Access Compliance Report

Public Rights-of-Way

(Curb Ramps)

Intersection ID: N/A	Main Street: ENDAHVEN_LN	Cross Street: N_COMMUNITY_HOUSE_RD	Location: SE
ADA ID: 7F690EF47580	Ramp Type: Perp	Initial Pass/Fail: Fail	Overall Compliance: No
Codes/Mitigation Info/Possible Solution		Field Measurements/Component Compliance	
Severity Score: 13.75

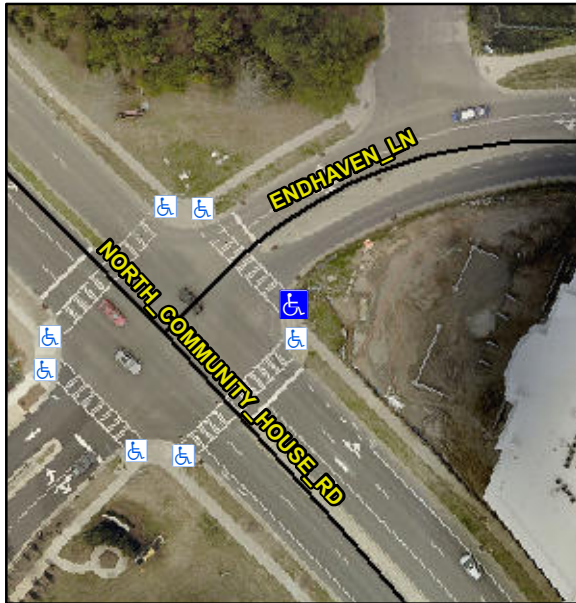
R304.2.2, R304.5.3

Compliance	Description	Data	Compliance	Description	Data
N/A	Ramp Length (in)	58.0	No	Ramp Slope (%)	8.9
Yes	Ramp Width (in)	48.0	No	Ramp XSlope (%)	4.6
N/A	Flare Type LT	N/A	N/A	Flare Type RT	N/A
N/A	Flare Slope LT (%)	N/A	N/A	Flare Slope RT (%)	N/A
N/A	Flare Traversable LT?	N/A	N/A	Flare Traversable RT?	N/A
N/A	Landing Length (in)	N/A	N/A	DWS Provided?	N/A
N/A	Landing Width (in)	N/A	N/A	DWS Contrast?	N/A
N/A	Landing Slope (%)	N/A	N/A	DWS Length (in)	N/A
N/A	Landing X Slope (%)	N/A	N/A	DWS Full Width?	N/A
N/A	Landing Curb? (Y/N)	N/A	N/A	DWS Offset (in)	N/A
N/A	Shared Landing?	N/A			
N/A	Gutter Ponding?	N/A	N/A	Gutter Slope (%)	N/A
N/A	Gutter Lip Ht (in)	N/A	N/A	Gutter X Slope (%)	N/A
N/A	Painted X Walk1?	Yes	N/A	Painted X Walk2?	N/A
	X Walk 1 Direction	To NW		X Walk 2 Direction	N/A
N/A	X Walk 1 Width (in)	114.5	N/A	X Walk 2 Width (in)	N/A
	X Walk 1 Slope (%)	1.6		X Walk 2 Slope (%)	N/A
	X Walk 1 X Slope (%)	2.0		X Walk 2 X Slope (%)	N/A

Remove & Replace Entire Ramp.
